## *Addendum to* PowerPC 604™ RISC Microprocessor User's Manual: **PowerPC 604e™ Microprocessor Supplement and User's Manual Errata**

- Part 2: Errata to *PowerPC 604 RISC Microprocessor User's Manual* contains corrections to the user's manual.

**Figure 9-1. MESI Cache Coherency Protocol—State Diagram (WIM = 001)**

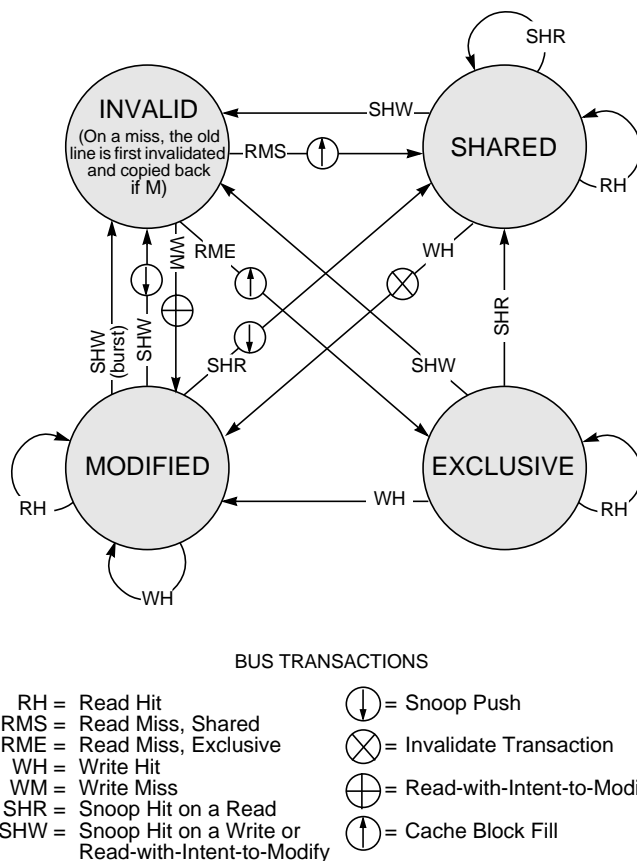
3.6.4, Page 3-14      The following should replace Figure 3-6 and Figure 8-15 in Chapter 8.

**Figure 8-20. Burst Transfers with Data Delay Controls**

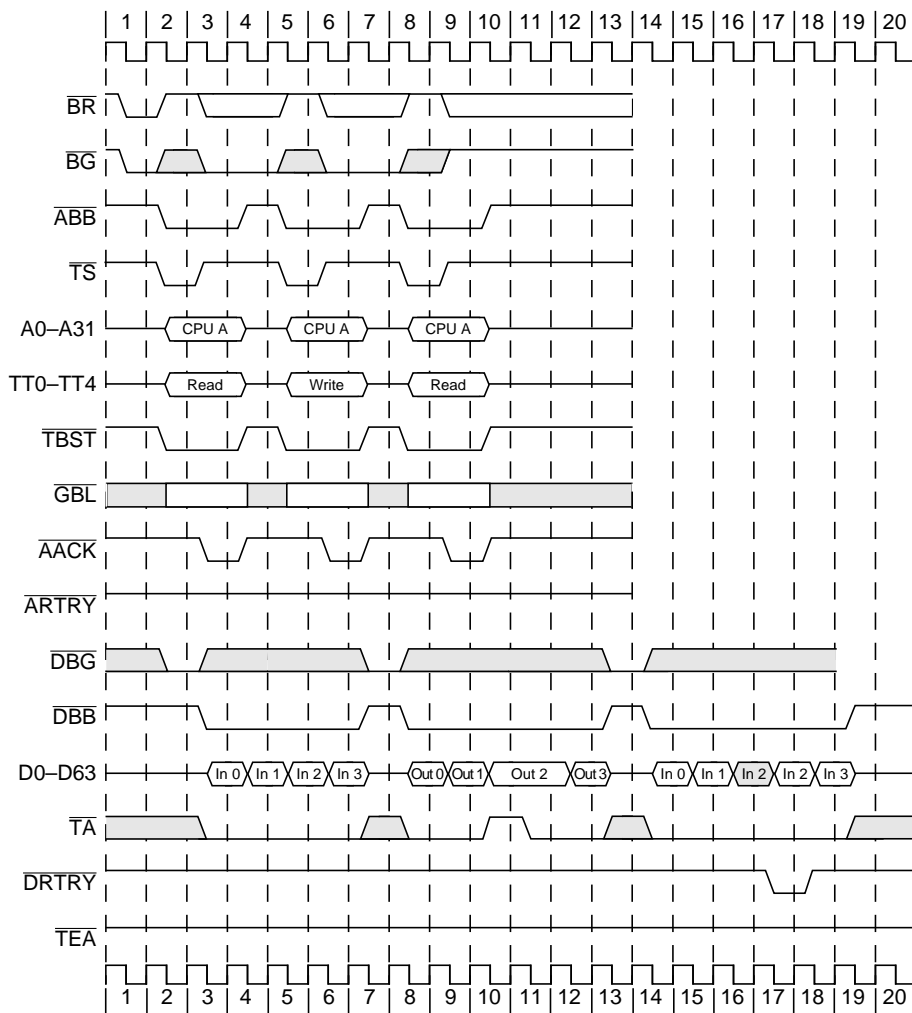
8.5, Page 8-36      Replace Figure 8-20 with the following:

**Figure 8-21. Use of Transfer Error Acknowledge (TEA)**

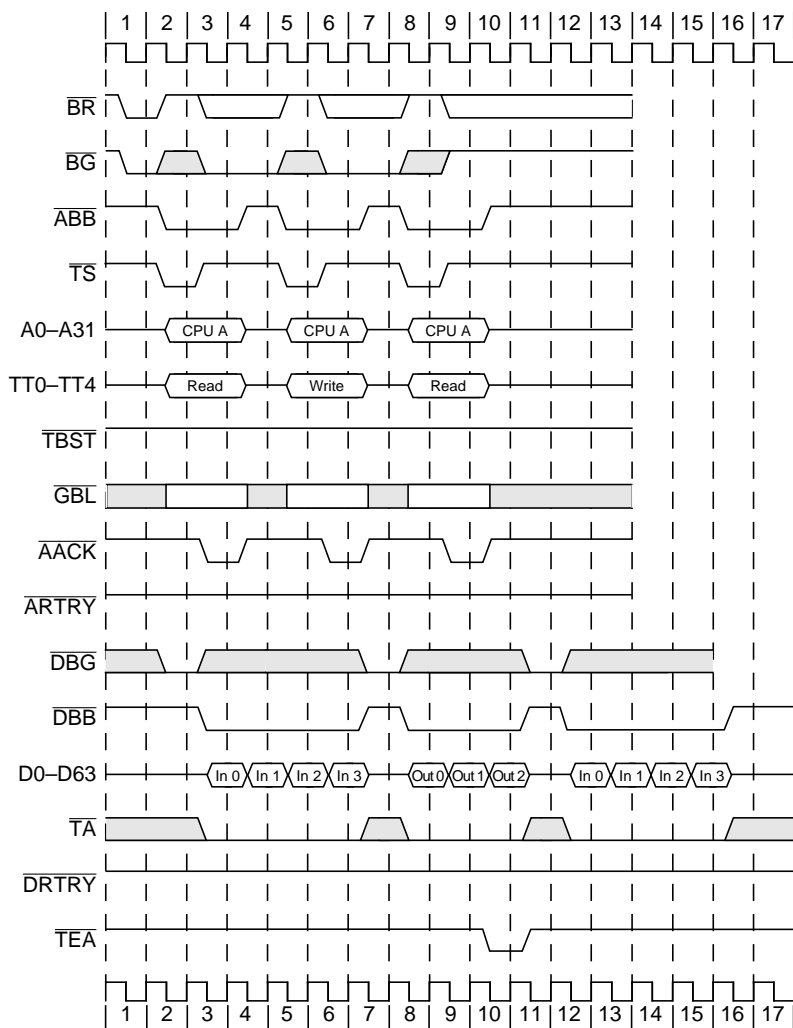
8.5, Page 8-37      Replace Figure 8-21 with the following:
